Subject: **Docket No. 50-361  
Response to Request for Additional Information (RAIs 20, 21, 22, 23, 24,  
26 & 31)  
Regarding Confirmatory Action Letter Response  
(TAC No. ME 9727)  
San Onofre Nuclear Generating Station, Unit 2**

**Response to RAIs 20, 21, 22, 23, 24, 26 and 31**

Nominal AVB Clearance

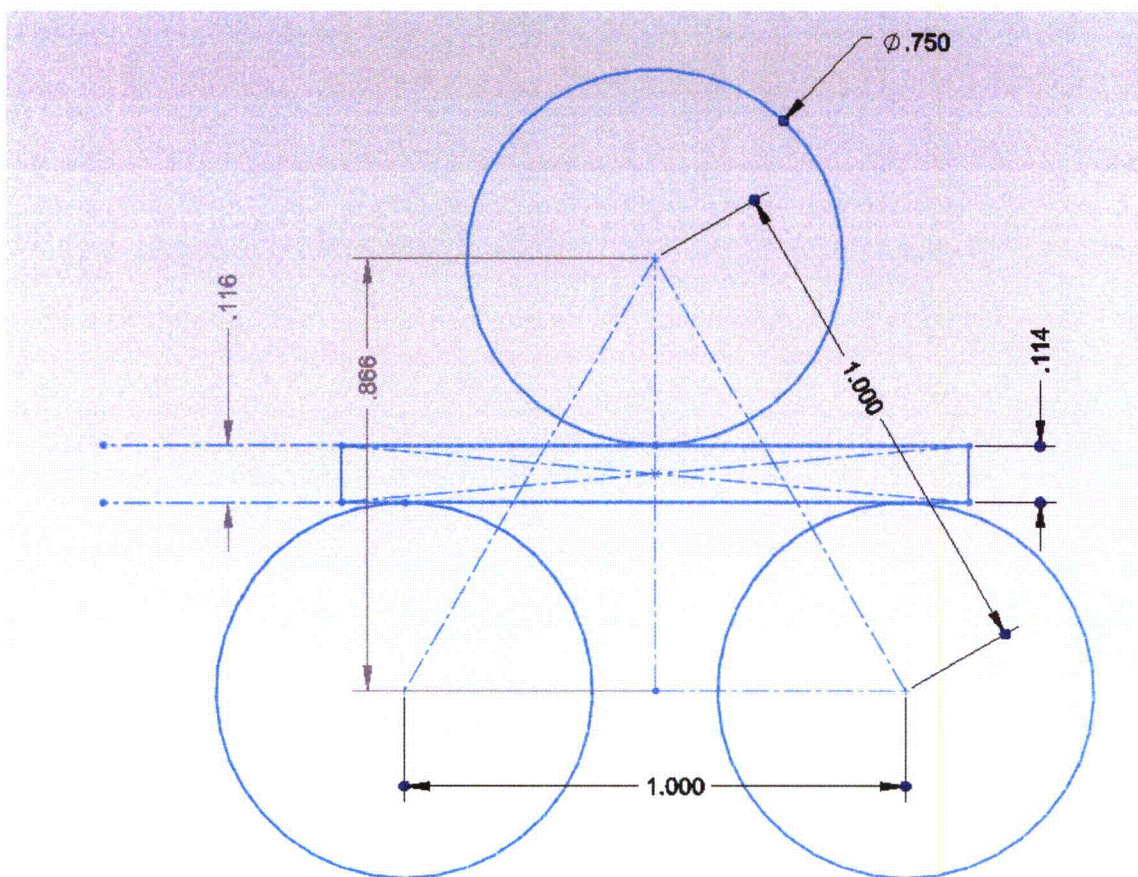
Reference 3, page 17 of 129, refers to tube-to-support design clearance of 2 mils diametral. Confirm that this is the nominal diametral clearance under ambient conditions, or clarify the statement otherwise.

The nominal design values for dimensions needed to determine the tube to anti vibration bar (AVB) clearance are summarized below.

Tube outside diameter = 0.750 in.

AVB thickness = 0.114 in.

Tube-to-tube spacing = 1.000 in.

As shown in the figure below, the nominal clearance between the adjacent tube columns is 0.116 in. Therefore, the nominal tube to AVB clearance is 1 mil. The total clearance is twice this value or 2 mils. This is the nominal design clearance at ambient conditions.

Reference 3, Figure 6-2: Zones Used to Develop Characteristic Distributions of Contact Forces for Each AVB in the Zone

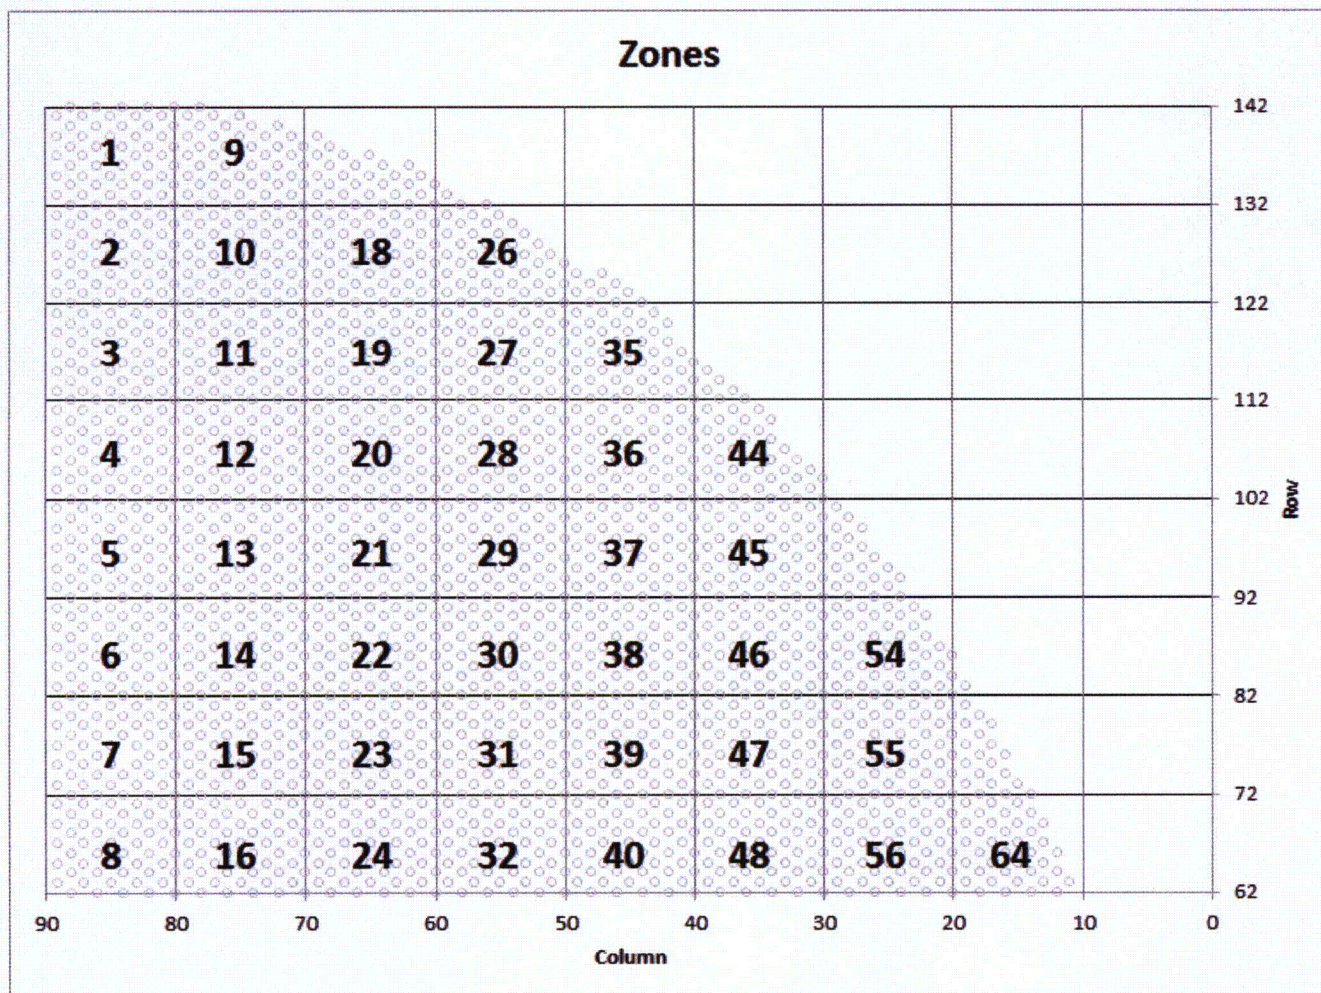
Reference 3, page 57 of 129, first full paragraph beginning with the words "Figure 6-1" The third sentence states, "... it is not practical to use an individual run of the quarter model as a single Monte Carlo trial for contact forces." However, the staff was unable to ascertain from the subsequent discussion exactly what was done as an alternative? Nor was the staff able to discern this from Reference 6, Appendix 9. Provide or cite by reference a more complete description of how the cumulative distributions of contact forces were determined. For example, what is a "run"? What does it mean to "combine runs"? How were zones employed in order to provide a more practical approach? Are all tubes in a given zone assumed to have the same initial clearances, final clearances, and contact forces? Do all AVB #5 in a zone have the same cumulative distribution of contact forces? Is a Monte Carlo performed for each zone?

5. These small local regions are called zones. The zones are typically 10 rows by 10 columns in extent as shown in RAI Reference 3, Figure 6-2 (reproduced below). Because of the triangular pitch any given column contains only even numbered or odd numbered rows. Thus the typical zone contains 50 tubes. In the periphery, some zones have slightly smaller or slightly larger numbers of tubes as shown on the figure. All tubes in a given zone do not have the same initial clearances.

Tubesheet Map of Dents Found in Pre-Service Inspection, SG 2E-088

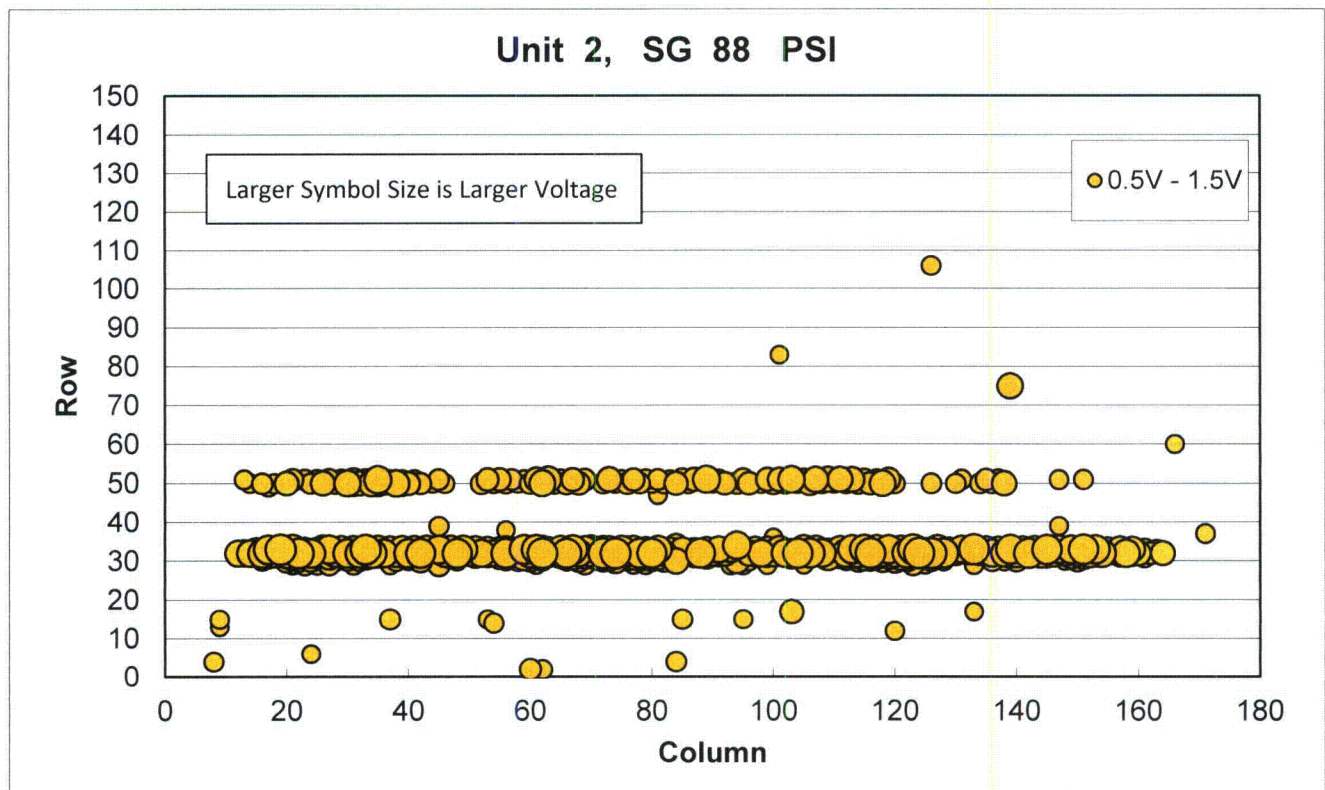
Reference 3 - Provide figures similar to Figures 6-19 and 6-20 for Unit 3, SG E-088, and Unit 2, SG E-088.

The requested plots are attached for steam generator (SG) 2E-088 and SG 3E-088. The 4 plots (Figures 6-19, 6-20 and the two below) were prepared by Mitsubishi Heavy Industries, LTD (MHI) based on pre-service inspection (PSI) data.
